From: Hamlet, Robert, EMNRD
Sent: Thursday, June 27, 2019 8:01 AM
To: 'Andresen, Rebecca'
Cc: Venegas, Victoria, EMNRD; Bratcher, Mike, EMNRD; Michelson, Jason C
Subject: RE: South Culebra Bluff 13 Fed Well No 4, Inspection iTM1734233912

From: Andresen, Rebecca <Rebecca.Andresen@arcadis.com>
Sent: Thursday, June 13, 2019 12:27 PM
To: Hamlet, Robert, EMNRD <Robert.Hamlet@state.nm.us>
Cc: Venegas, Victoria, EMNRD <Victoria.Venegas@state.nm.us>; Bratcher, Mike, EMNRD <mike.bratcher@state.nm.us>; Michelson, Jason C <JMichelson@chevron.com>
Subject: [EXT] South Culebra Bluff 13 Fed Well No 4, Inspection iTM1734233912

NM OCD Environmental Map

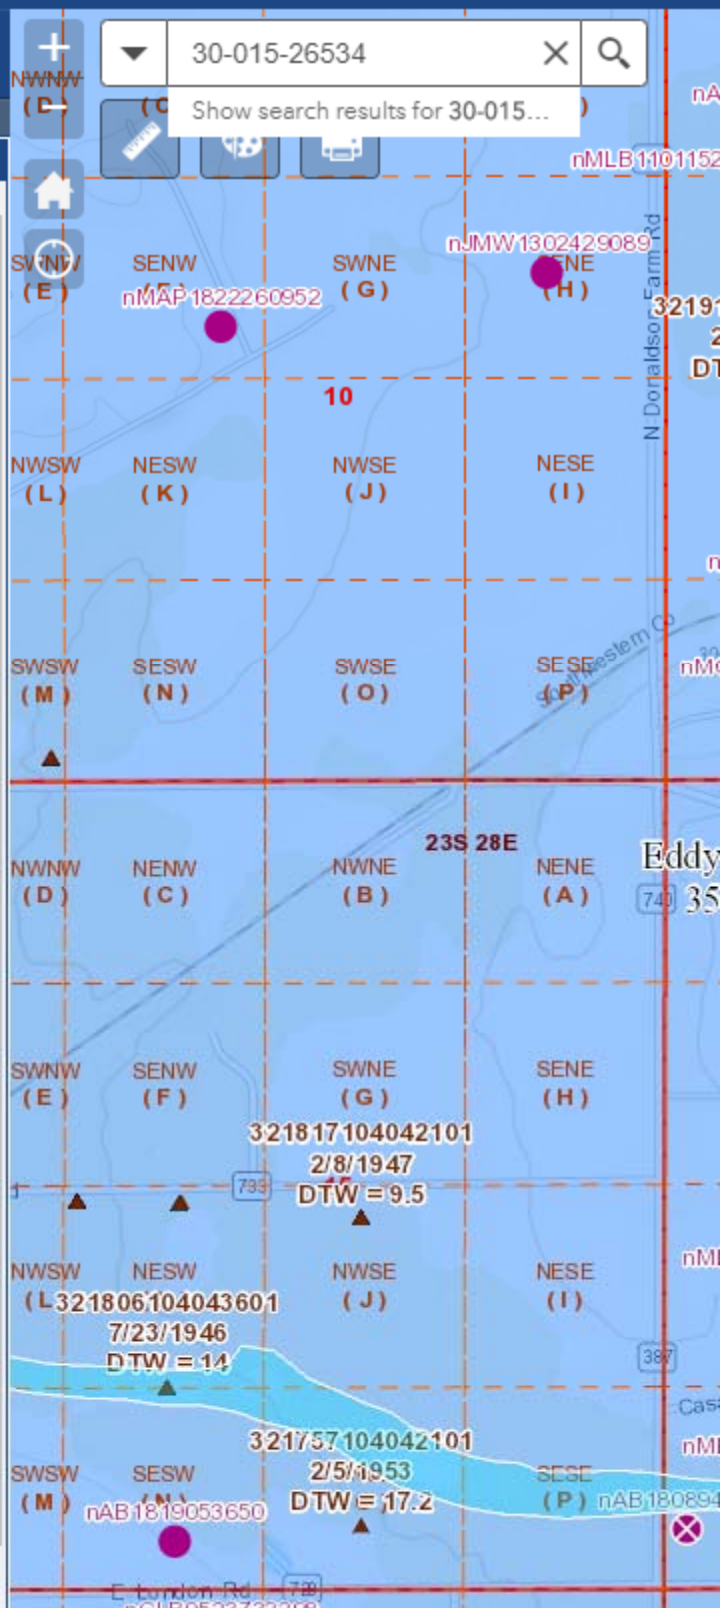
This location is technically in a National Flood Hazard Zone and is high priority as far as clean-up is involved. The depth to groundwater is extremely shallow in this area (10-30'). Due to the sensitive nature at this location, an extension will likely not be an option.

Please make sure all wells are addressed with respect to the staining issues. Please remove the stained soil and replace with clean soil. Take a picture after the stained soil has been replaced with clean soil. Send in a letter and picture for each well in the "Inspection Detail Section" explaining that the violation has been addressed and we will administrate the violation has been taken care.
